PERMIT COVER MEMO

FILE NAME: Hardee County Class I Landfill

PERMIT #: 38414-011-SO/01

PERMIT SUMMARY: This permit application is for renewal of the operation permit for the existing Hardee County Class I landfill, including operation of the Phase II, Section I lateral expansion.

Figure O-1. Gas Probe Locations, Hardee County Landfill Expansion, Hardee County, Florida

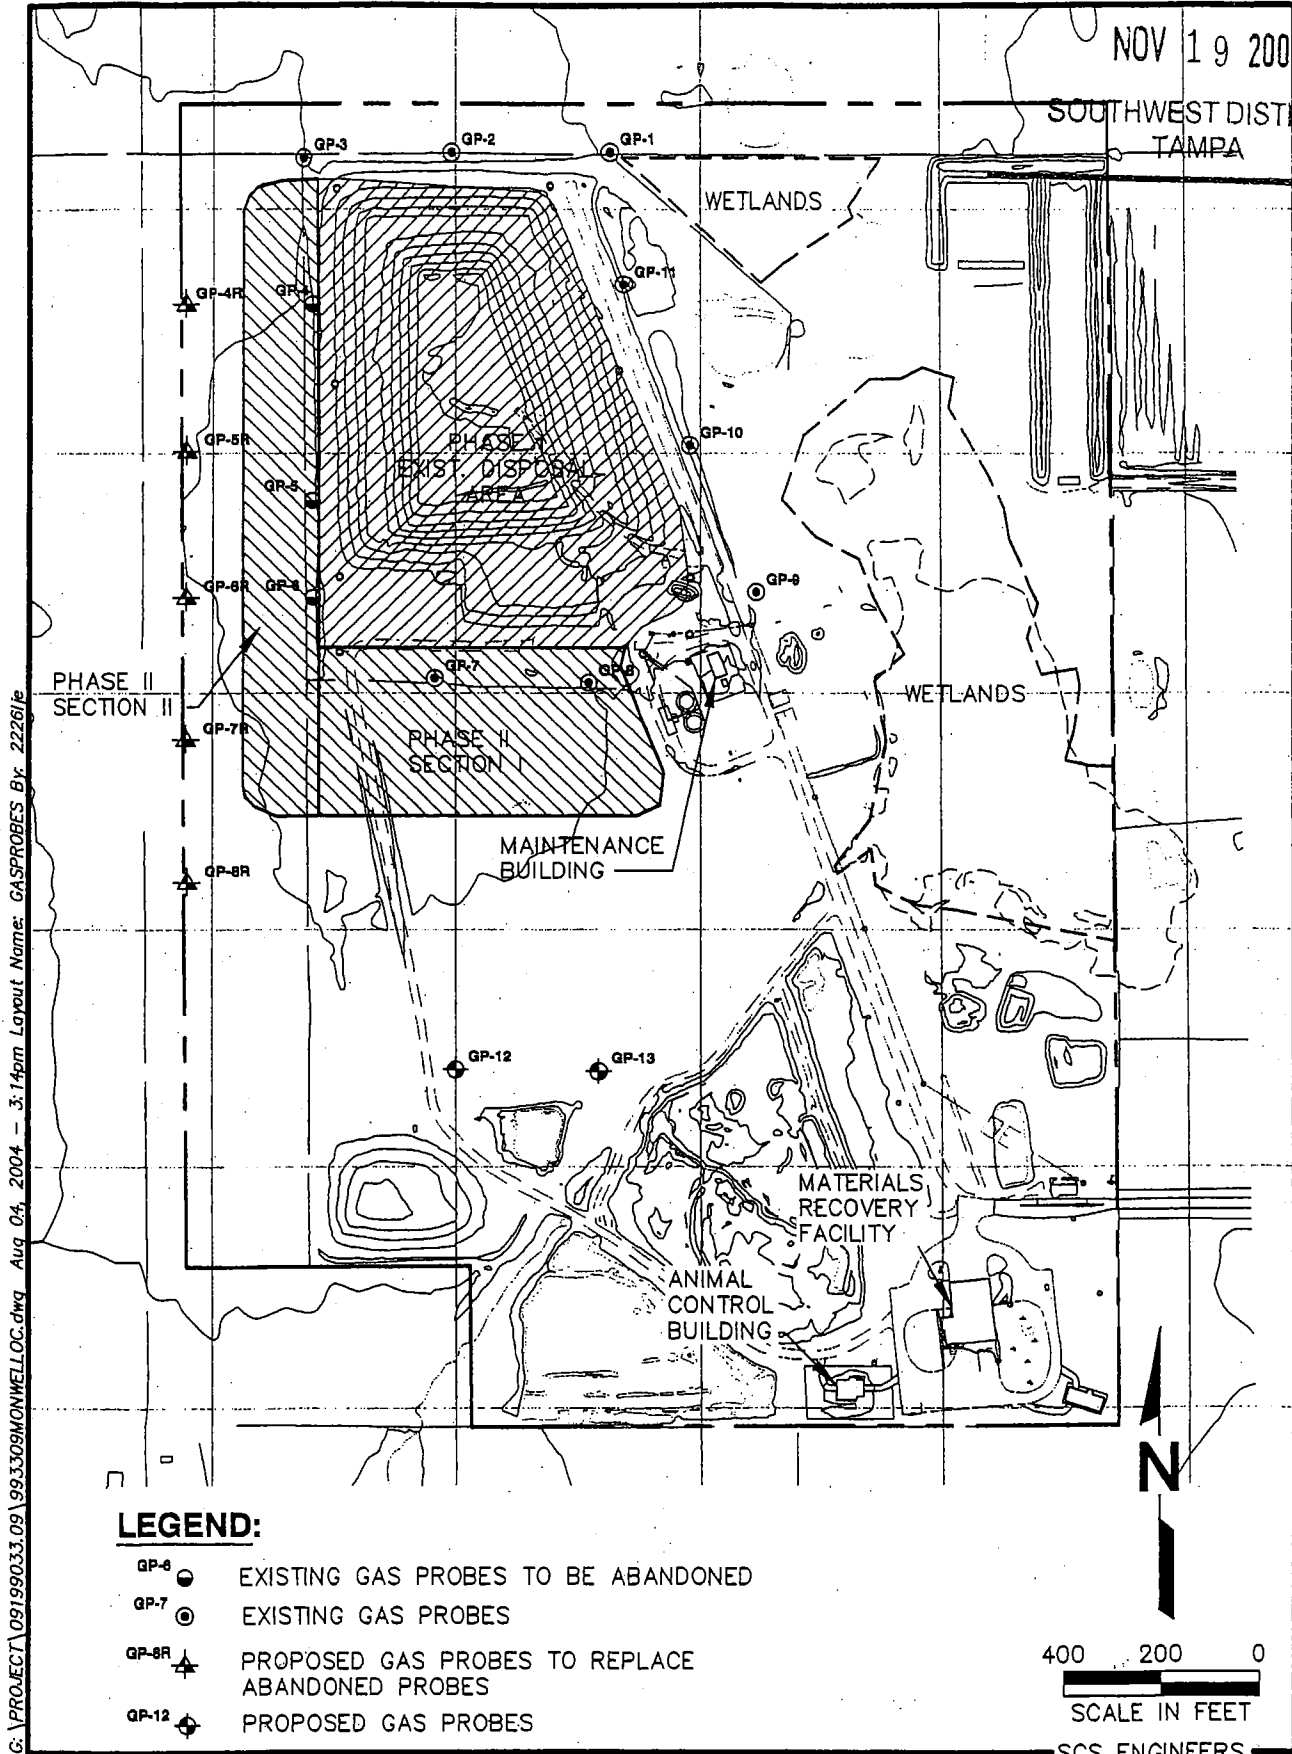
19. Section L.9: The site layout map contained in Appendix K (current revision) appears to be missing two of the gas monitoring probes (GP-12 and GP-13). A previous submittal (Figure H-1, revision dated November 19, 2004) shows all the probes. Please revise the map to show all gas monitoring probes.
